MAC/PHY Delay Variability: Corner Cases and Solutions

Introduction

Proposed Solution for Case 1 [2]

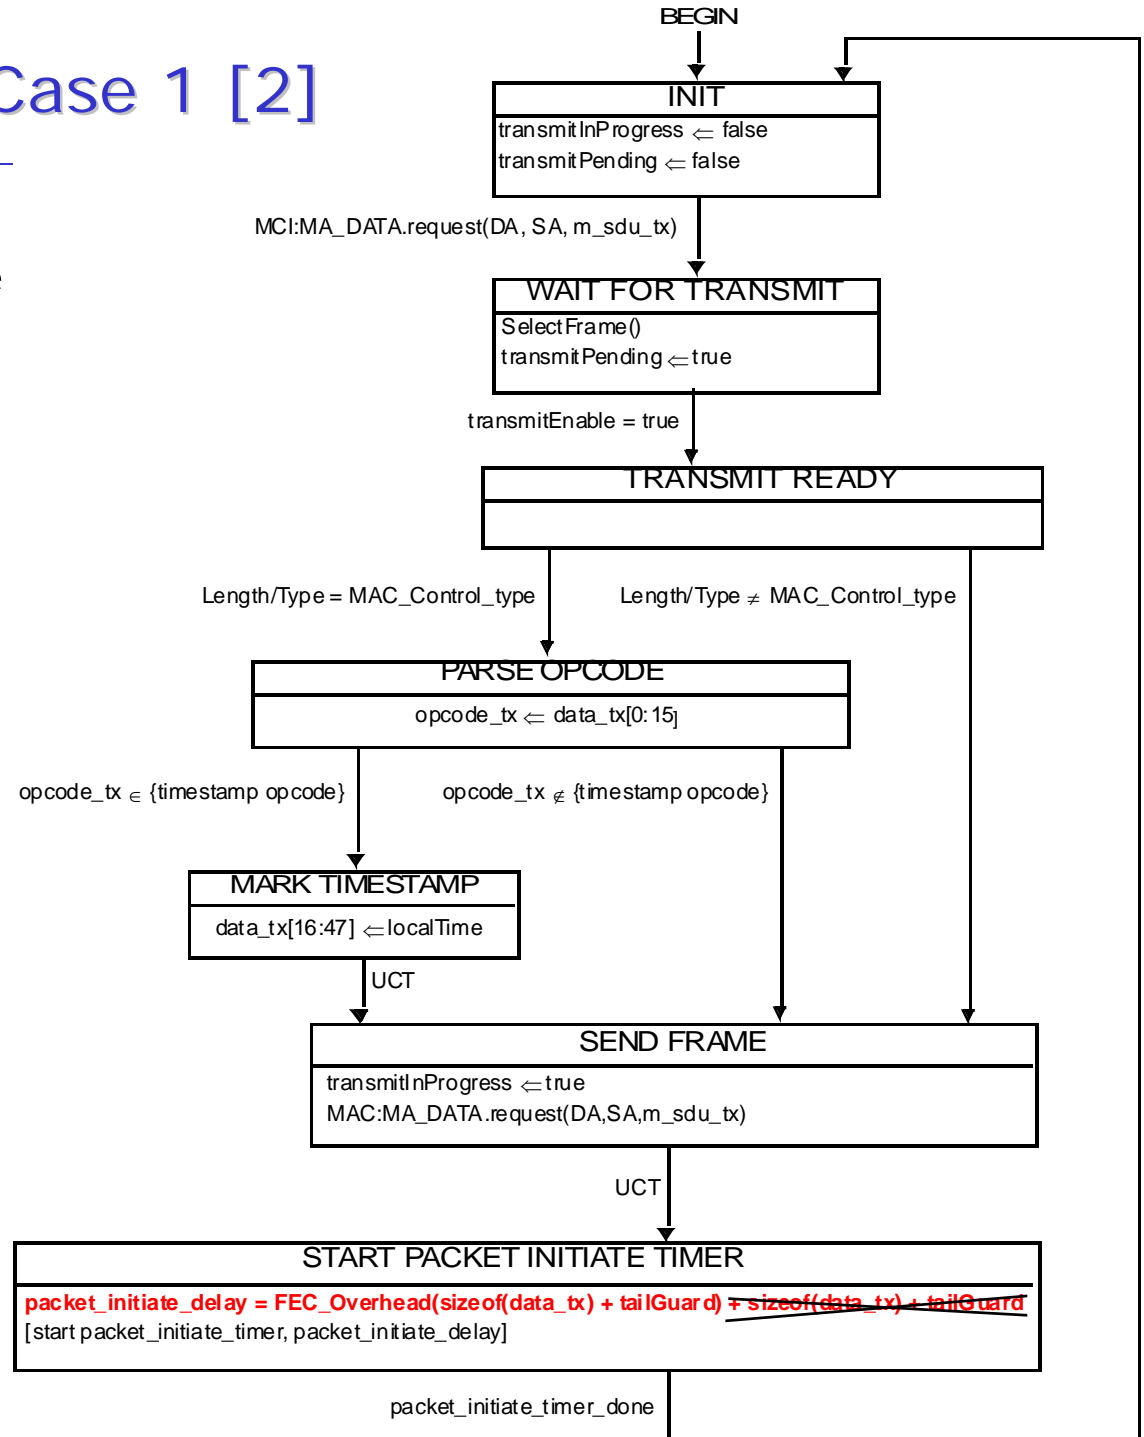
- In state START PACKET INITIATE TIMER, replace

$$\text{packet_initiate_delay} = \text{FEC_Overhead}(\text{sizeof}(\text{data_tx}) + \text{tailGuard}) + \text{sizeof}(\text{data_tx}) + \text{tailGuard}$$

with

$$\text{packet_initiate_delay} = \text{FEC_Overhead}(\text{sizeof}(\text{data_tx}) + \text{tailGuard})$$

Proposed Solution for Case 1 [3]

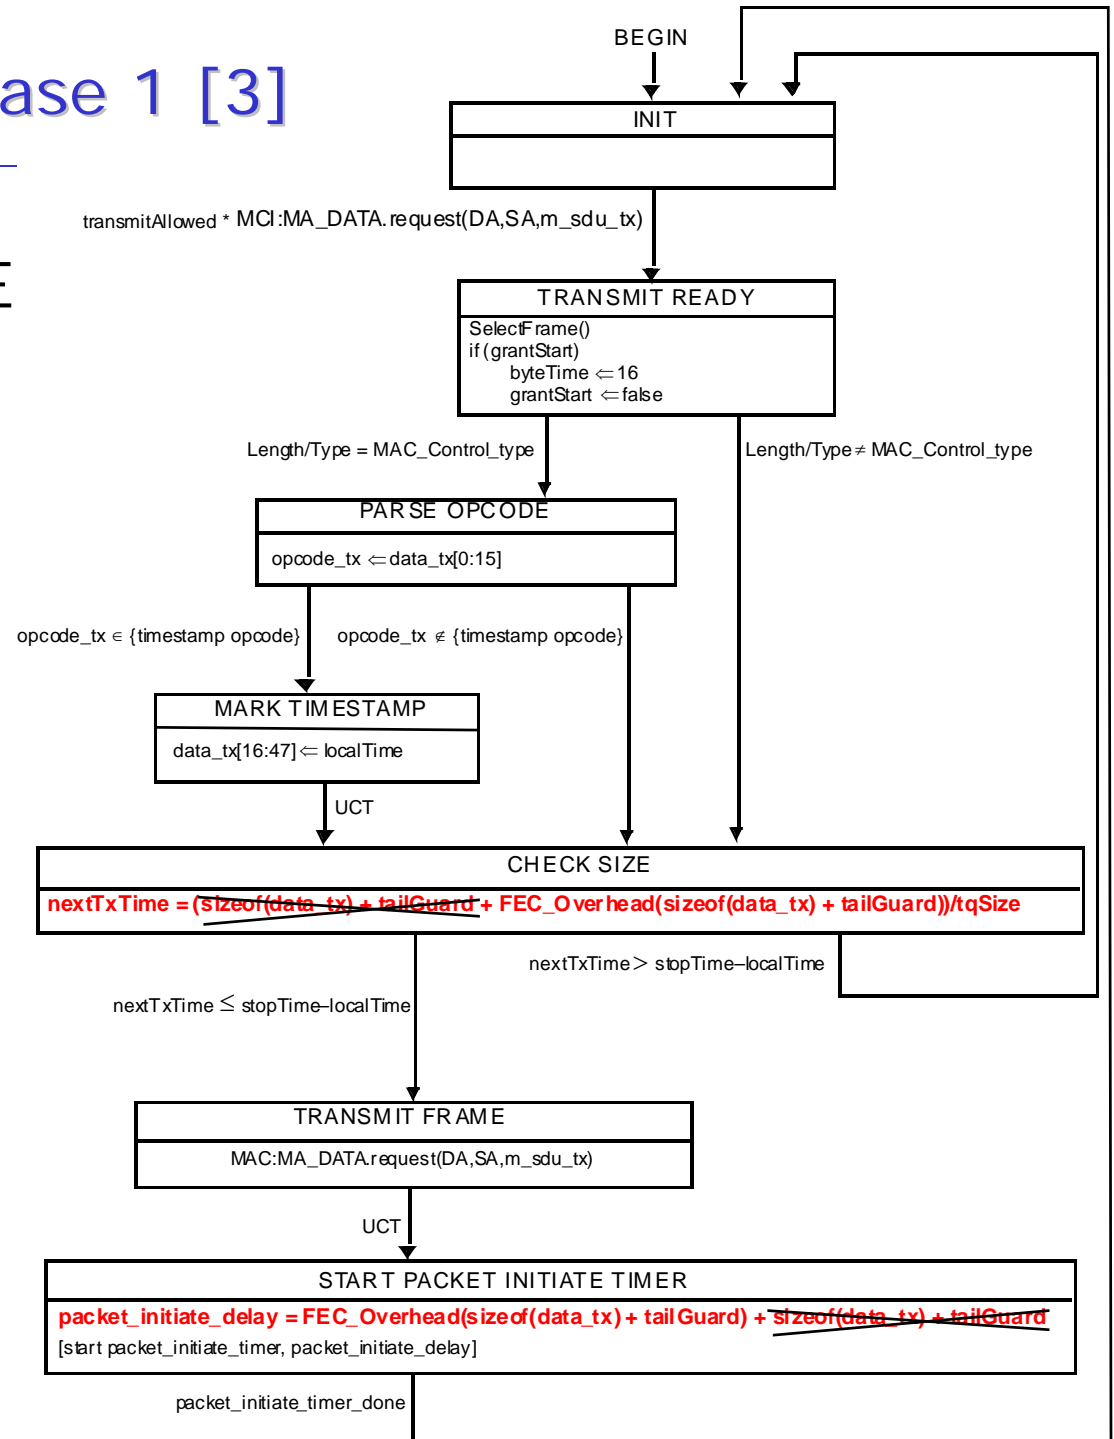
- In states CHECK SIZE and START PACKET INITIATE TIMER, delete

$\text{sizeof}(\text{data_tx}) + \text{tailGuard}$

as shown

Proposed Solution for Cases 2 & 3

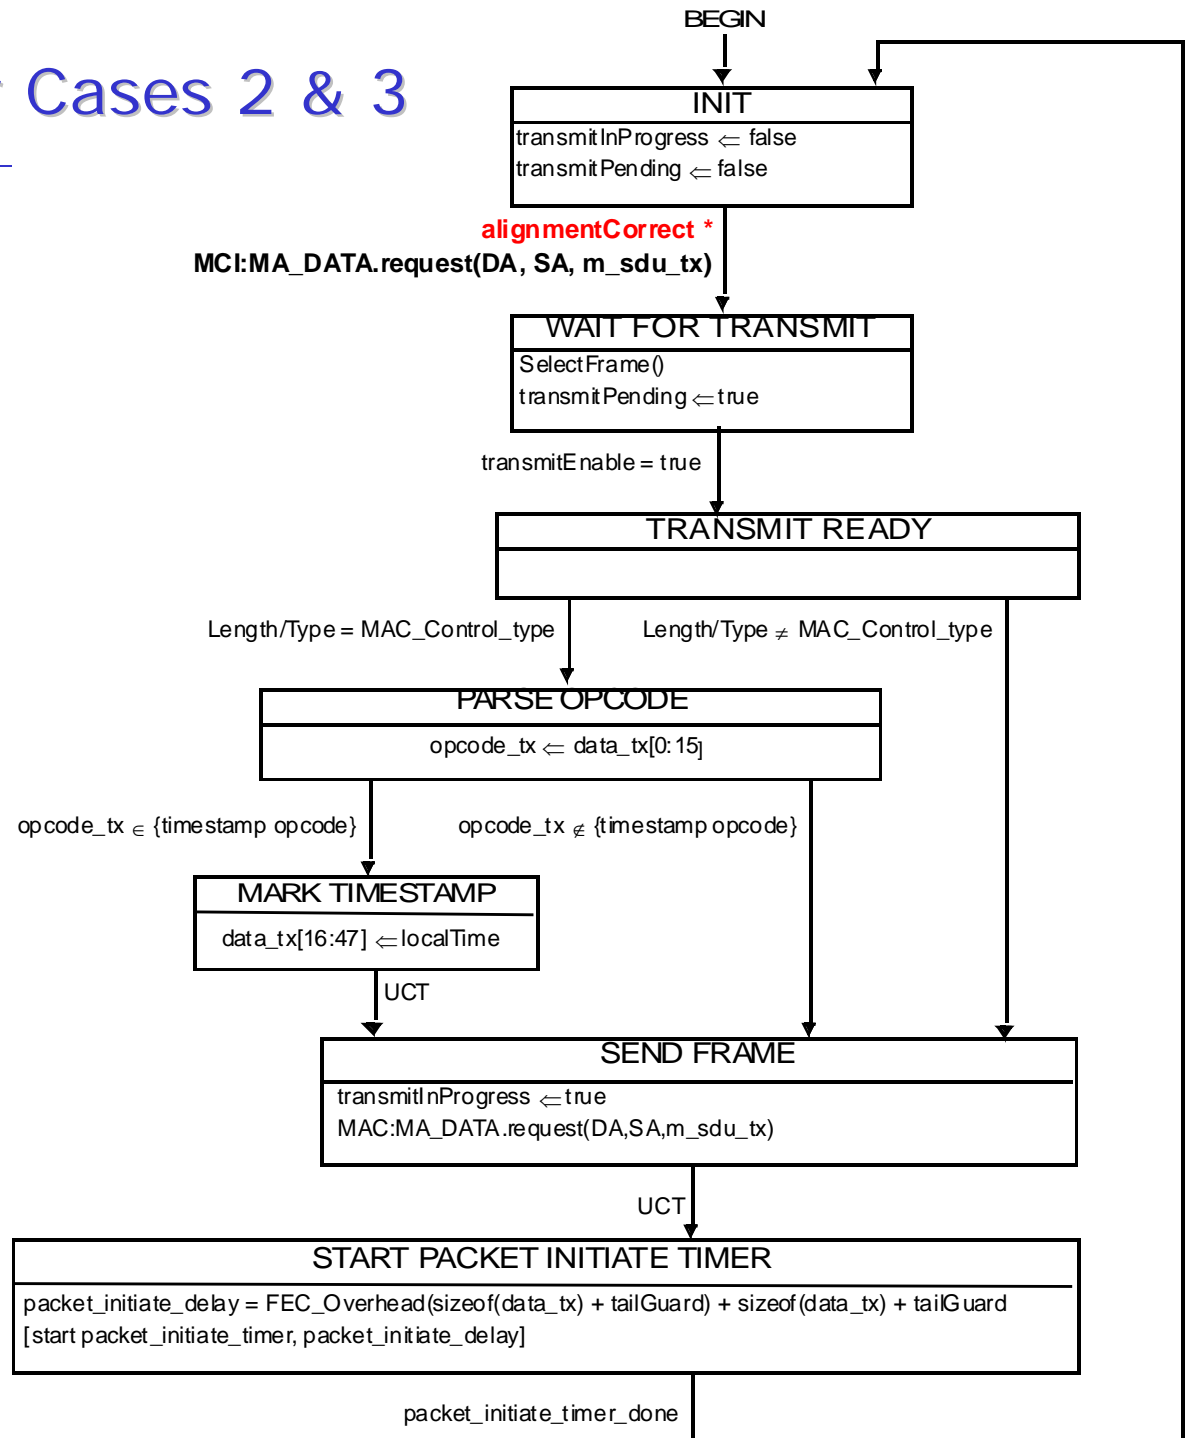
- Modify transition from INIT to WAIT TO TRANSMIT to allow frames through only
 - On column boundary and
 - During payload portion of FEC codeword.
- MAC Control frames that arrive during the parity portion will be delayed **before timestamping** until the parity part completes and column boundary is aligned.
- OLT Control Multiplexor (Figure 77-13) →

Proposed Solution for Cases 2 & 3

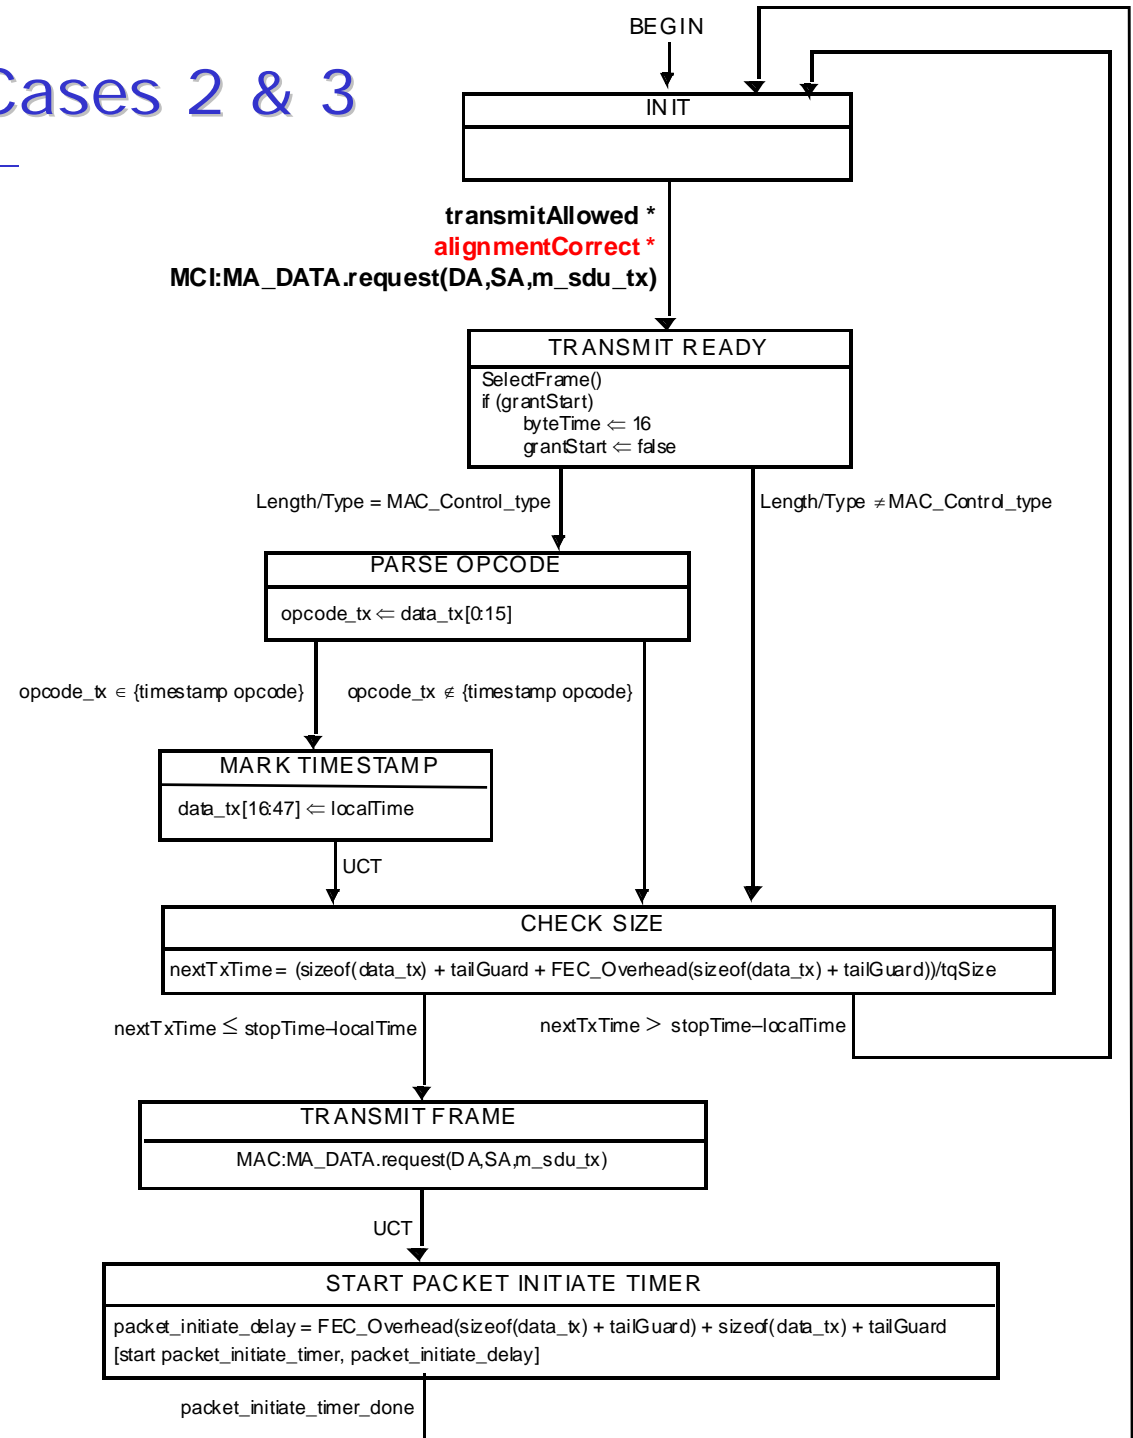
- Similar modification should be made to ONU Control Multiplexor.

- ONU Control Multiplexor (Figure 77-14) →**
